HARTZELL PROPELLER INC.
ALERT SERVICE BULLETIN
TRANSMITTAL SHEET
HC-ASB-61-378
Propeller - Counterweight Clamp Inspection

February 09, 2018

Revision 2 is issued to change the following in this Alert Service Bulletin:

Eddy Current Inspection: Area E Only
Figure 1

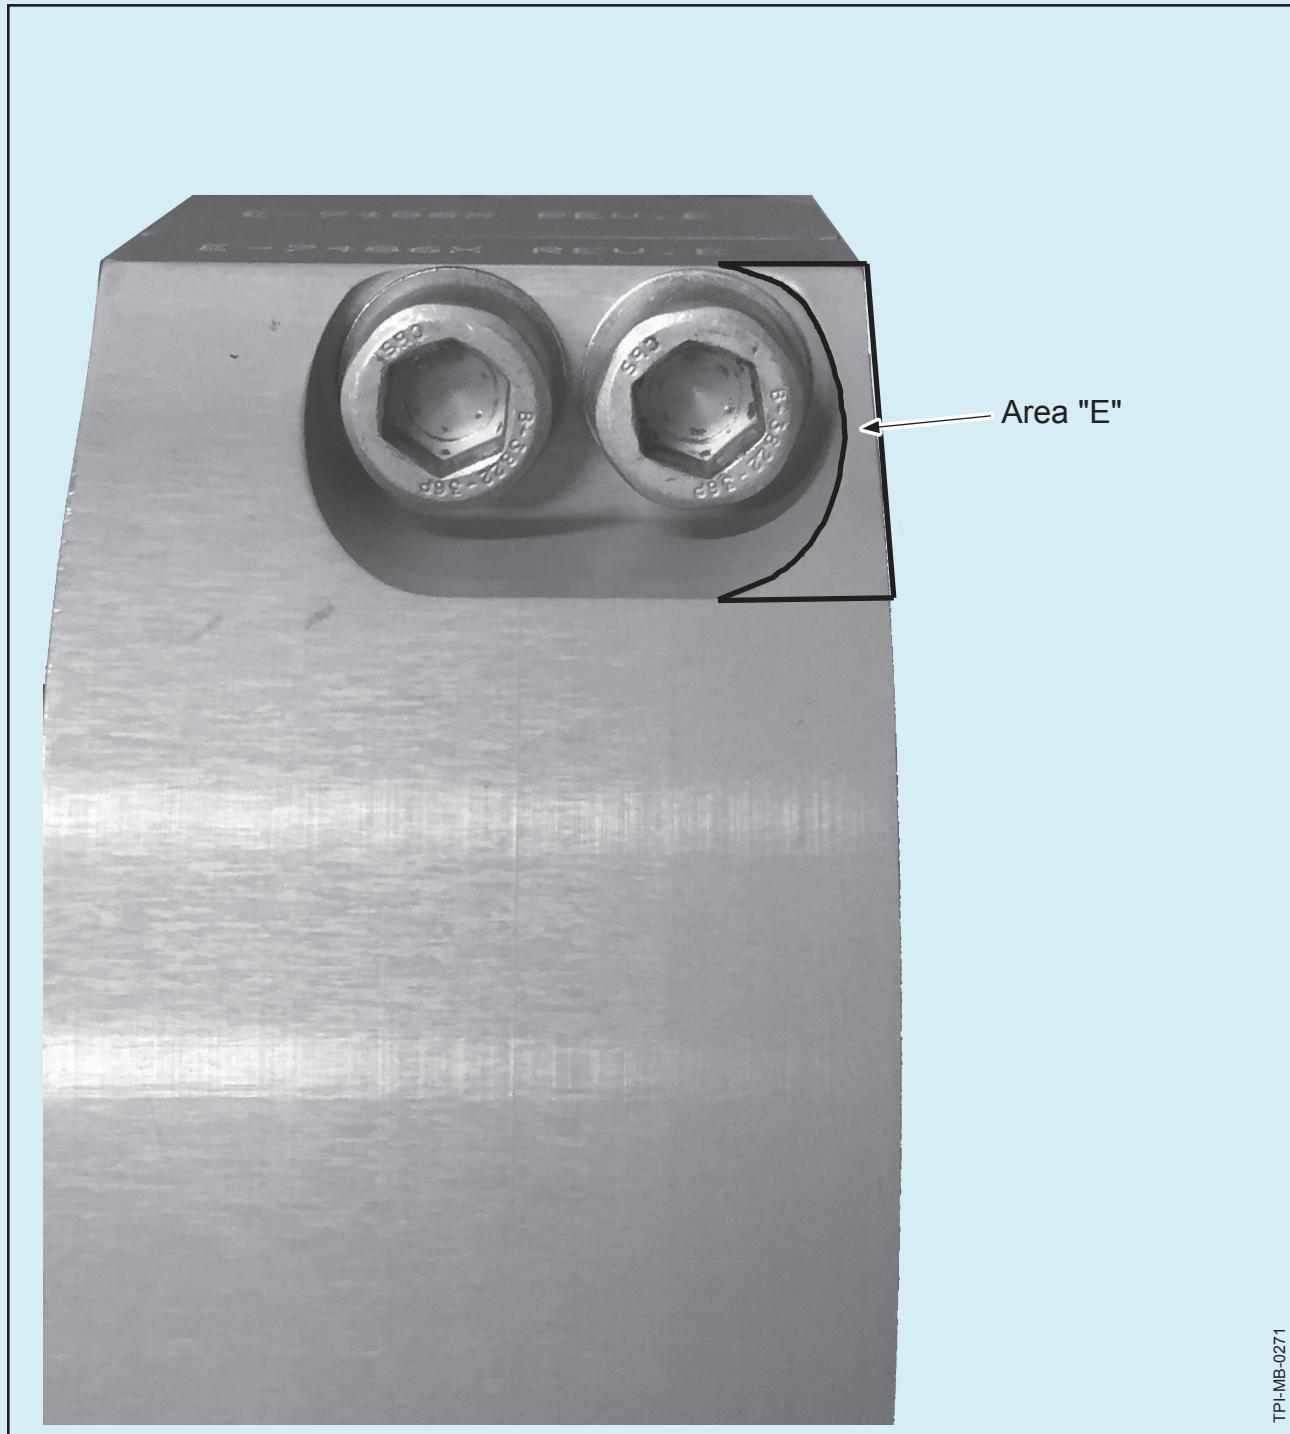
- (a) A shielded, 200-500 KHz, pencil-type probe, 2 mm maximum diameter is required to inspect Area E.
- (b) Use the test specimen TE121 or equivalent for calibration.
 - 1 The test specimen TE121 is a 1 inch x 4 inch (25 mm x 101 mm) aluminum block, 0.350 inch (8.89 mm) thick with reference notches that are 0.008 inch (0.20 mm), 0.020 inch (0.50 mm), and 0.040 inch (1.01 mm) deep and 0.003 inch (0.07 mm) and 0.005 inch (0.12 mm) wide.

- (c) Hold the probe firmly on the test specimen TE121 or equivalent with the coil perpendicular to the surface.
 - 1 Slide the probe across the 0.008 inch (0.20 mm) reference notch and make a record of the meter deflection.
 - (d) Obtain a 50% amplitude signal.
 - (e) A signal readout that is equal to, or greater than 3 times the readout from surface noise is desired.
- (5) Using the appropriate probe, perform an eddy current inspection of Area E of the counterweight clamp (refer to Figure 1) in accordance with the Eddy Current Inspection chapter of Hartzell Propeller Inc. Standard Practices Manual 202A (61-01-02).
- (a) If there is any indication exceeding a ratio of 3:1 signal amplitude to noise amplitude in these areas, replace all five counterweight clamps in accordance with the Accomplishment Instructions in this Alert Service Bulletin before further flight.

Counterweight Clamp Nut Removal/Torque Sequence

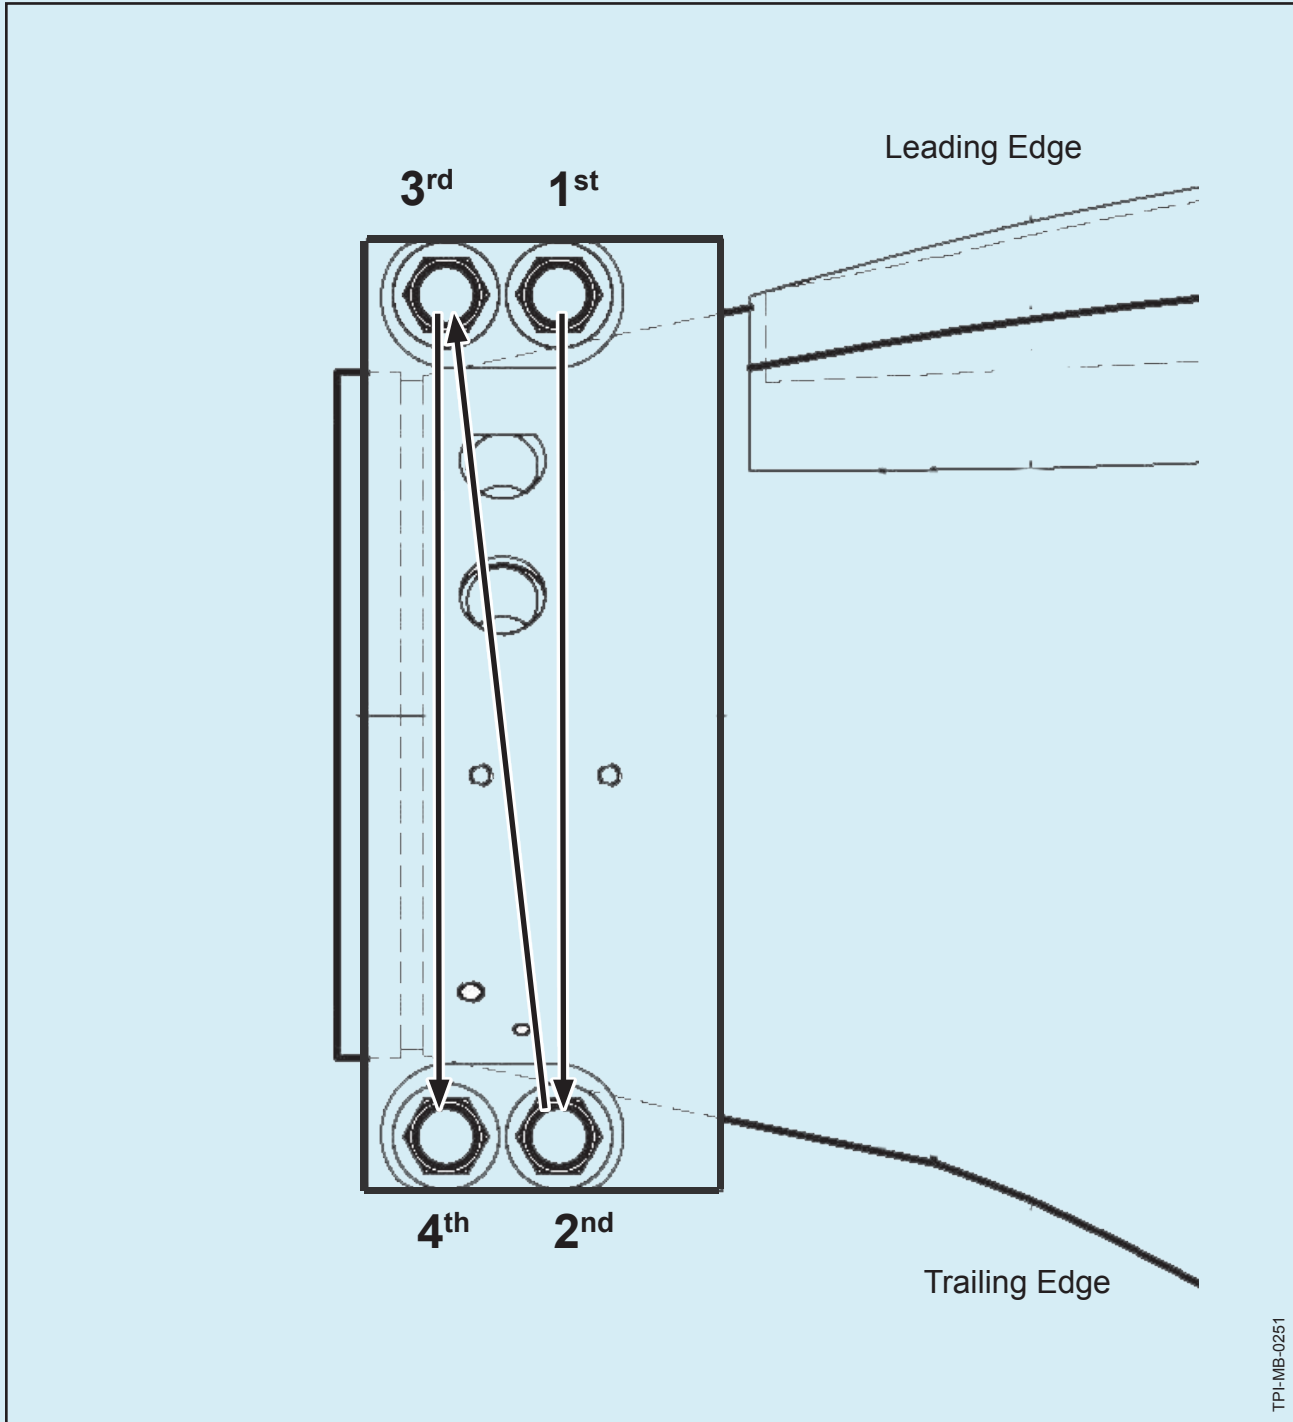
CAUTION: THE COUNTERWEIGHT CLAMP SCREWS MUST BE REMOVED, REINSTALLED, AND TORQUED ONE AT A TIME AND IN SEQUENCE TO PREVENT DAMAGE TO THE COUNTERWEIGHT CLAMP. REFER TO FIGURE 4 FOR THE PROPER SEQUENCE.

- (5) Remove one counterweight clamp screw in accordance with the sequence shown in Figure 2.
- (a) Using Stoddard solvent CM23 or equivalent, clean the screw and the counterweight clamp.
- (b) Inspect the screw, nut, and washers for corrosion and damage.
- 1 Replace any damaged or corroded hardware. Refer to the Material Information section in this Alert Service Bulletin for part number information.

- (8) Using the sequence shown in Figure 2, repeat steps 3.B.(5) through 3.B.(7)(b) for the remaining counterweight clamp screws.

- (9) After all counterweight clamp nuts have been torqued to 15 Ft-Lbs (20 N•m), use the same sequence shown in Figure 2 to torque each counterweight nut to 20 Ft-Lbs (27 N•m).

- (a) After all counterweight clamp nuts have been torqued to 20 Ft-Lbs (27 N•m), use the same sequence shown in Figure 2 to re-torque each counterweight nut at 20 Ft-Lbs (27 N•m) until none of the nuts rotate.

Eddy Current Inspection: Areas A, B, C, D
Figure 3

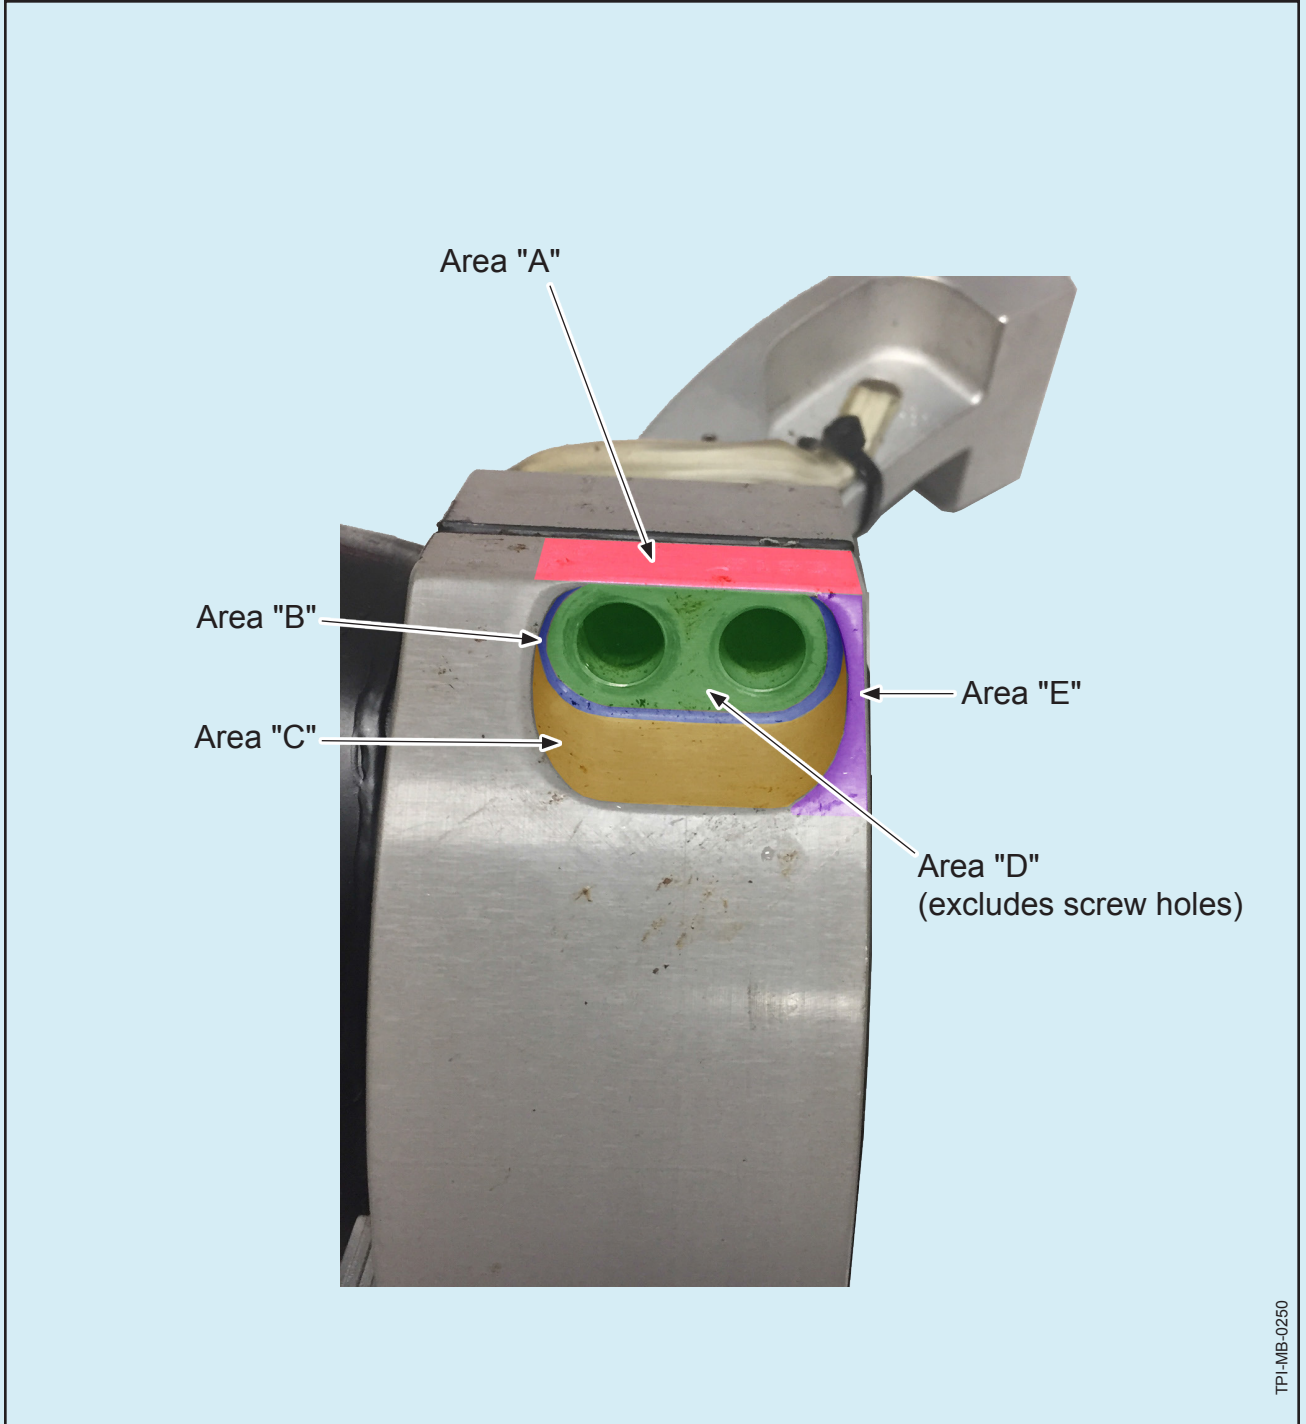
- (6) Using the appropriate probe, perform an eddy current inspection of Areas A, B, C, and D of the counterweight clamp (refer to Figure 3) in accordance with the Eddy Current Inspection chapter of Hartzell Propeller Inc. Standard Practices Manual 202A (61-01-02).
- (a) If there is any indication exceeding a ratio of 3:1 signal amplitude to noise amplitude in these areas, replace all five counterweight clamps in accordance with the Accomplishment Instructions in this Alert Service Bulletin before further flight.

- (10) Visually examine Area "C" and Area "E" of the counterweight clamp (refer to Figure 3) for damage that may have occurred during hardware installation.
 - (a) If there is damage that has compromised the anodize coating, clean the damaged area using Stoddard solvent CM23 or equivalent, then apply Ardrex AV 30 to the damaged area in accordance with the manufacturer's instructions.
